# **Additional Information**

## **Ordinary Meeting**

**Thursday, 24 March 2022**

**RE: MCU21/0342 & OpW21/0528 - 10 & 16 Brisbane Road and 7 & 9 First Avenue, Mooloolaba  
Councillor Additional Information Request Response #1**

Proposed First Avenue loading bay flush pavement design

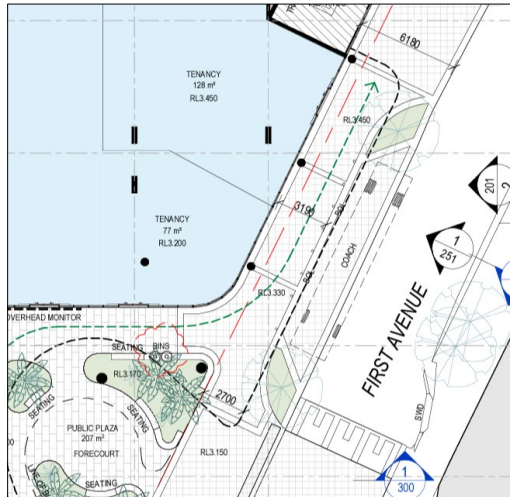
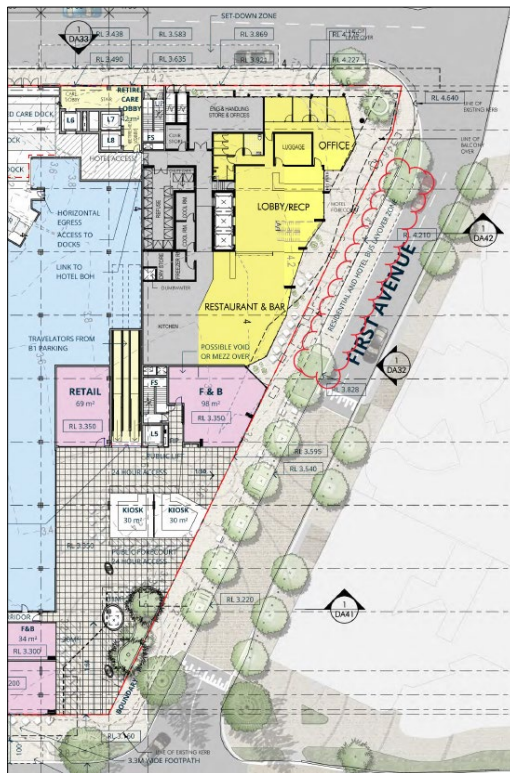
#### **8. Why is the development utilising a proposed loading bay within the First Avenue road reserve to set-down coaches and not providing an on-site bus parking space?**

The Applicant has proposed to construct a loading bay within the road reserve of First Avenue along with other streetscape improvements, to supplement the on-site separate loading dock and porte cochere that are accessed from Brisbane Road that caters for mini-buses and all vehicle movements except for coaches. It is anticipated that most vehicle movement associated with the proposed hotel can be managed by the on-site private loading dock and porte cochere, with coach arrivals being the only movements that require the larger space via the proposed public loading bay on First Avenue.

This area will be a full-time loading zone and signed accordingly. This loading bay is not for the sole use of the proposed hotel but will be infrequently used for the setting-down of coaches associated with the hotel. The public loading bay will be a community benefit within an area that lacks a dedicated area for commercial activities and passenger set-down.

The loading bay will be designated by bollards and a flush paving design that complements the adjoining footpath, allowing the loading bay to be trafficable by pedestrians while not in use, establishing an overall footpath width of approximately 6m. This approach is consistent with the 2018 Abacus MCU17/2169 approval over the site, and other hotel examples such as the Capri Hotel located 83 Albert Street, Brisbane.

As detailed within the Detailed Assessment Report included in the Ordinary Meeting report (OM Agenda page 106) the development does not comply with Acceptable Outcome AO15.1 of the Transport and parking code that states that a resort complex where having more than 20 beds is to provide a minimum of one on-site bus

parking space. However, the development complies with Overall Outcomes c) and e) of the code whereby the proposed loading bay has been designed in a safe and efficient manner that can be shared with other users. Accordingly, pursuant to section 5.3.3 of the planning scheme, as the development complies with the overall outcomes of the code, the development complies with the code.
